**ISO/IEC JTC 1/SC 24****Computer graphics, image processing and environmental data representation****Secretariat: BSI (United Kingdom)****Document type:** Disposition of Comments Report**Title:** N 3454 ISO-IEC 18025 EDCS comments disposition 20121212 03**Status:****Date of document:** 2013-03-06**Expected action:** INFO**No. of pages:** 84**Email of secretary:** [charles.whitlock@bsigroup.com](mailto:charles.whitlock@bsigroup.com)**Committee URL:** <http://isotc.iso.org/livelink/livelink/open/jtc1sc24>

**Environmental Data Coding Specification (EDCS)**  
**ISO/IEC 18025 Edition 2**

**Resolution of DIS Comments**  
**12 December 2012**

**Figure 6.1 – Relationship between the EV values for a given associated EA instance collection”**

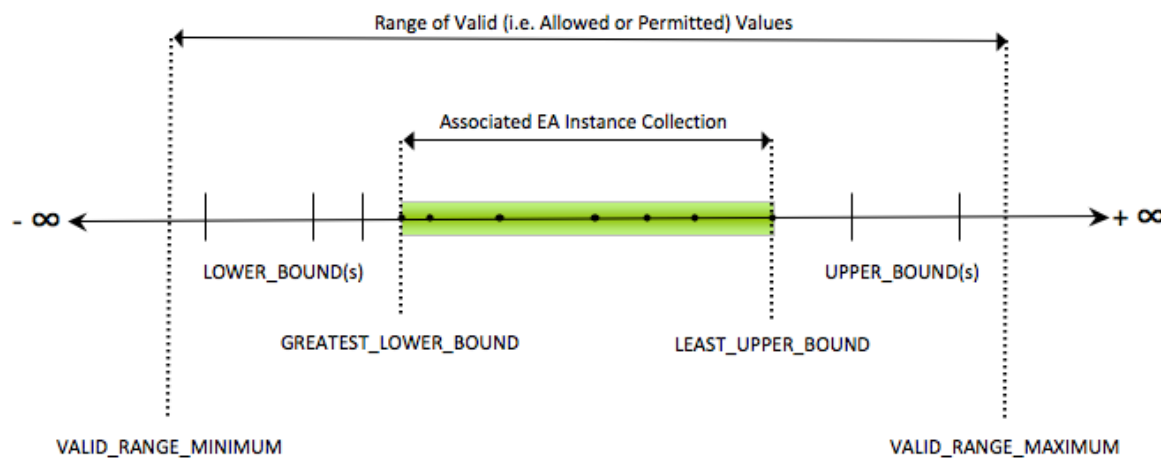
**SEDRIS\_T051:** In 6.3, after table 6.33, add the following as the new final paragraph:

“Figure 6.1 depicts, for a given EA instance collection, the relationship between the EV values of EVs VALID\_RANGE\_MINIMUM, LOWER\_BOUND, GREATEST\_LOWER\_BOUND, LEAST\_UPPER\_BOUND, UPPER\_BOUND, and VALID\_RANGE\_MAXIMUM.”

**RESOLUTION:** Accepted.
